LIVSEY & COMPANY, INC.
INDIANA & MICHIGAN ELECTRIC CO.
DONALD C. COOK NUCLEAR PLANT

DWN. S.B. DATE 6-8-78 CONTAINMENT BLDG.
CKD. C.B. DATE 6/29
ISSUED
REF. DWG. 1-5692
DWG. NO. 1-NSW-183
REV. 4

1-NSW-183
Lower Containment Ventilation
Unit 2 Return Line

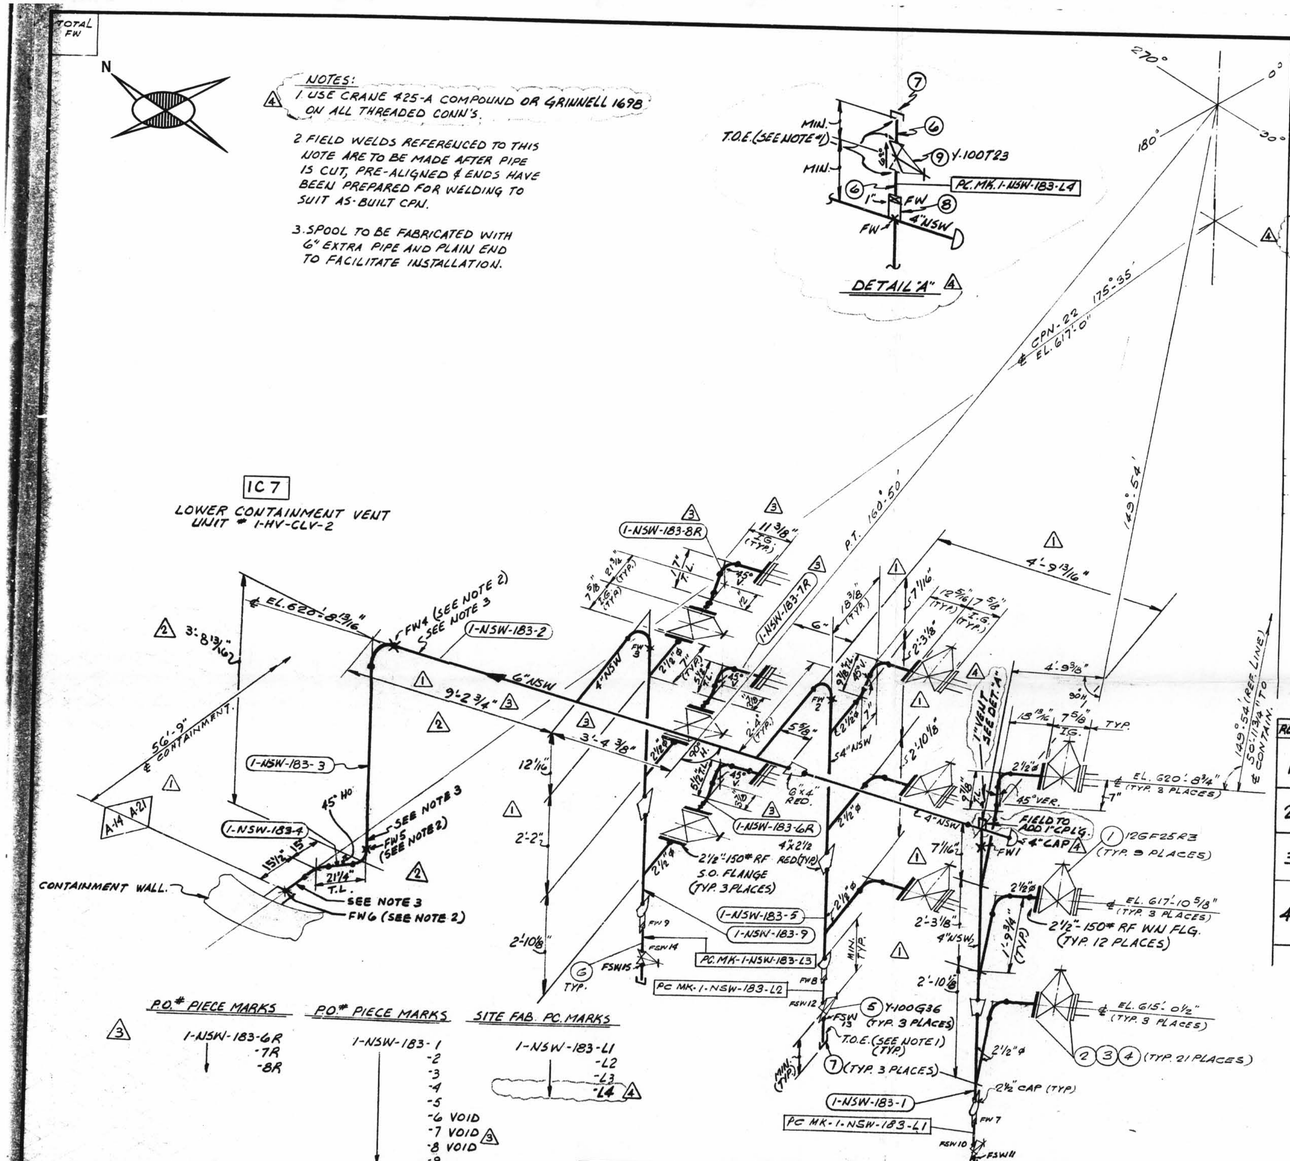
REV.	DATE	PR. CHK.	DESCRIPTION	REMARKS
1	7/3/72	JQ / LB	CHG'D FABRICATOR & ADDED VARIOUS DIMENSIONS AS NOTED. CHG'D LOC. OF FW1.	FAB ACTION REQ'D
2	7/26/72	A.S. / LB	REVISED CONFIGURATION OF PCS. 1-NSW-1-183-2, 3 & 4 PER A.E.P. ARRGT DWG. 1-5692 REV. 4	–
3	9/21/72	J.Q. / LB	DIMS 9'-2 3/4", 3'-4 3/8" & 11 3/8" WERE 9'-2 3/16", 3'-4 13/16" & 11 3/4" RESPECTIVELY. VOIDED PC MKS 1-NSW-183-6, 7 & 8. ADDED PC MKS 1-NSW-183-6R, 7R & 8R. AEP ARRGT DWG. 1-5692 REV. 4	FIELD ACTION/FAB REQ'D ACTION REQ'D
4	3/5/73	J.Q. / I.F.	REVISED BY N.P.S. DESIGNS. ADDED 1"x2 1/2" L TO PC MK 1-NSW-183-2, FW 4. FIELD NOTE 6, SITE FAB. PC MK 1-NSW-183-L4, DET. "A", B/M ITEMS 8 & 9. REV. NOTE 1, DET. "A", B/M ITEM 7. PER A.E.P. ARRGT. DWG. 1-5692 REV. 5	FIELD ACTION REQ'D –
